**Technical Service  
BULLETIN**

**M.I.L. "ON" DTC P0171 AND/OR P0174:  
ENGINE RUNNING LEAN**

**'04 Camry, Sienna & Solara (3MZ-FE)**

**ENGINE  
EG029-04**

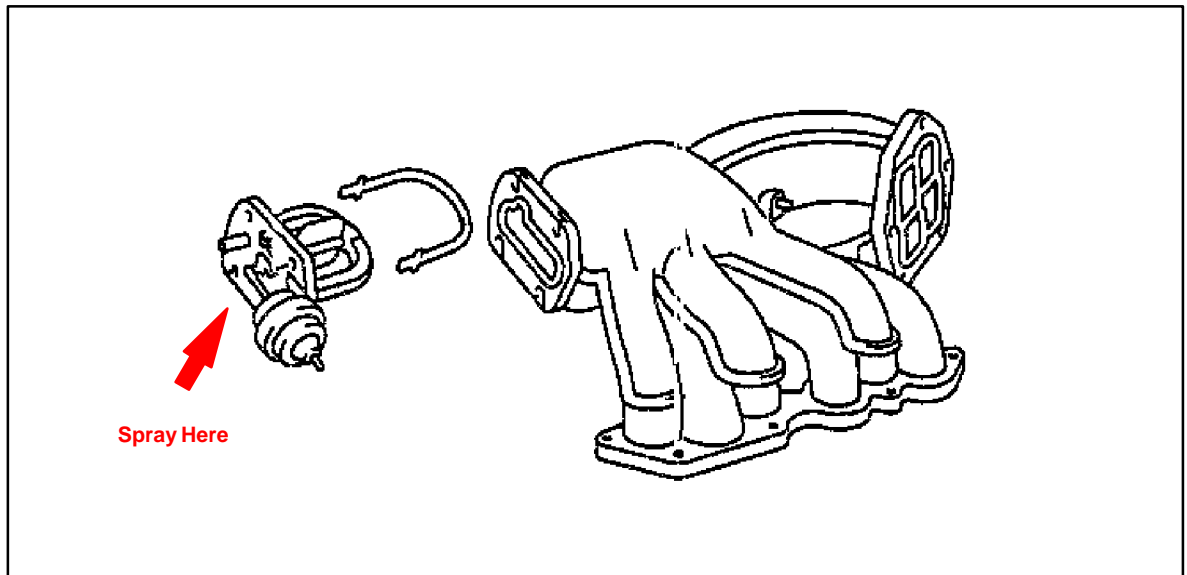
2. Spray carburetor cleaner near the Intake Air Control Valve pivot shaft and monitor Short Term Fuel Trim as indicated in step 1.

3. Was the short term fuel trim changing to a rich reading, or negative fuel trim in step 2?

**If Yes** – Replace the Intake Air Control Valve. Refer to the Technical Information System (TIS), 2004 model year applicable model Repair Manual: *Intake: Intake Air Control Valve Assy No. 2 (3MZ-FE): Replacement*.
